SHOREHAM NUCLEAR POWER STATION
UNIT 1

Shoreham Outstanding SER Issue #3

Shoreham Outstanding SER Issue #5
LOCA Loadings on Reactor Vessel Supports and Internals

SER OPEN ITEM #13

TABLE 223.90-1
PLANT SAFE SHUTDOWN
SELECTION OF SHUTDOWN SYSTEMS

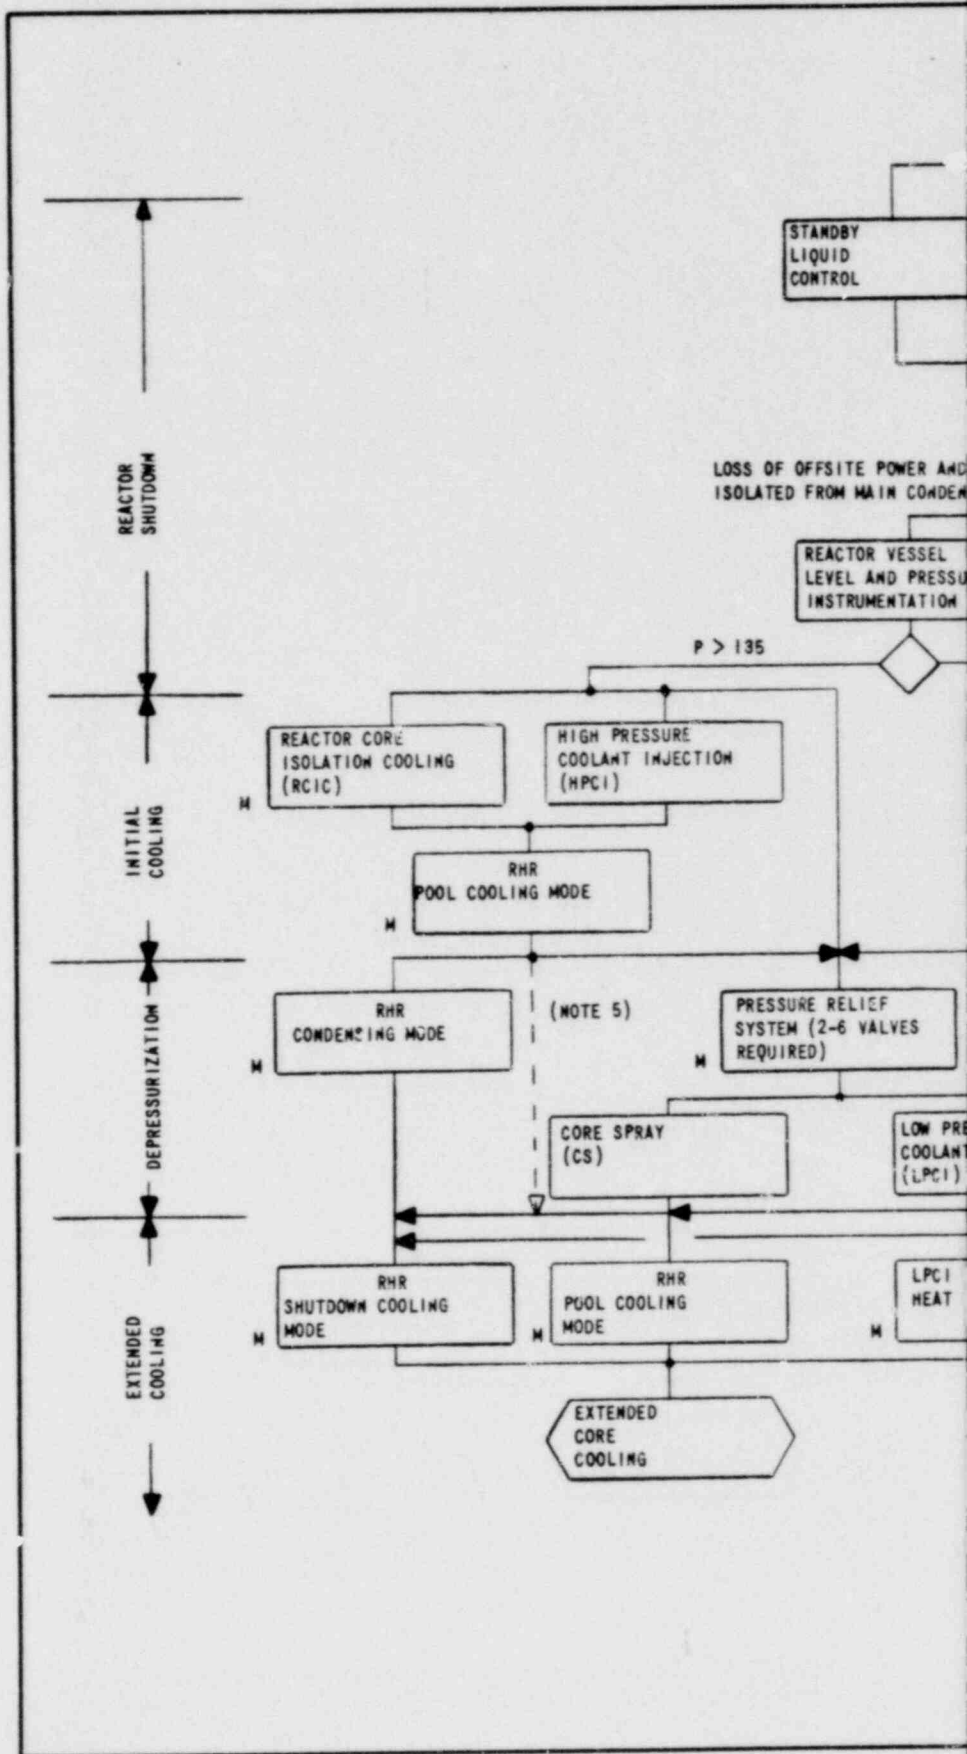
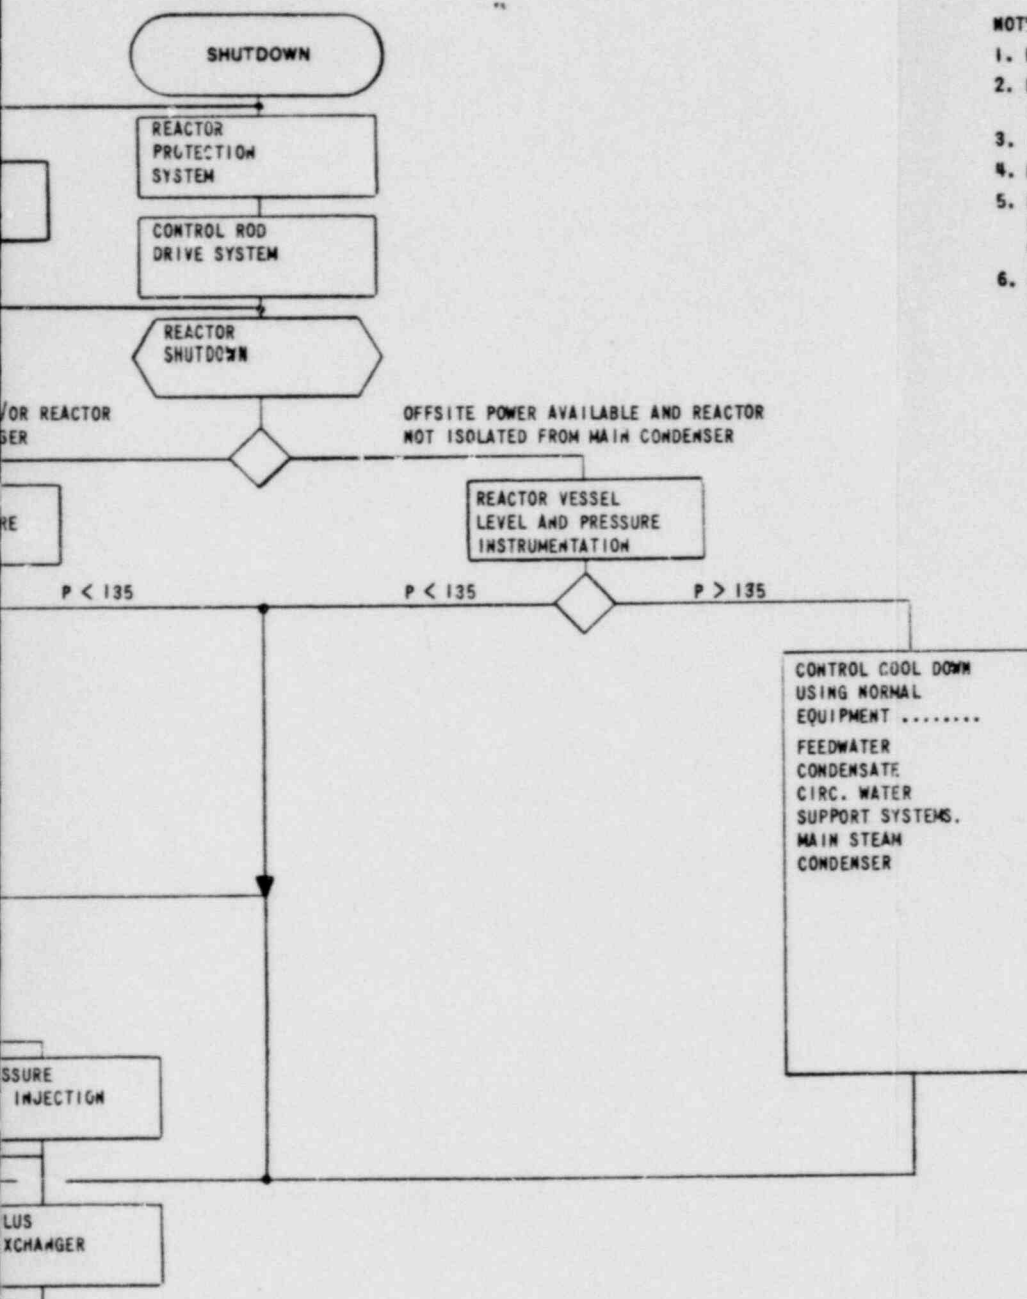
Provide a response to IE Bulletin 79-27, dated November 11, 1979, for Shoreham.

On Shoreham, a protection sequence for shutdown was developed showing the different paths that could be used to achieve cold shutdown. (Figure 223.90-1) Based on the sequence, it was determined that only Class 1E systems are necessary to achieve cold shutdown. Tables 223.90-1 and 2 list the Class 1E systems and components with power sources that could be used to achieve cold shutdown. Also, attached are Shoreham's Class 1E one-line diagrams.

1. RCIC IS AUTO START, MANUAL RESET.
2. RHR CONDENSING MODE REQUIRES NON-SAFETY INSTRUMENT AIR.
3. INSTRUMENTATION NOT SHOWN.
4. M - MANUAL.
5. NO FORCED COOLDOWN CAPABILITY THIS PATH HOWEVER PLANT REMAINS SAFE IN HOT SHUTDOWN CONDITION AND WILL EVENTUALLY DEPRESSURIZE.
6. ADDITIONAL FLEXIBILITY EXISTS IN THAT PATHS OF MANY OPERATIONS MAY BE RETRACED.
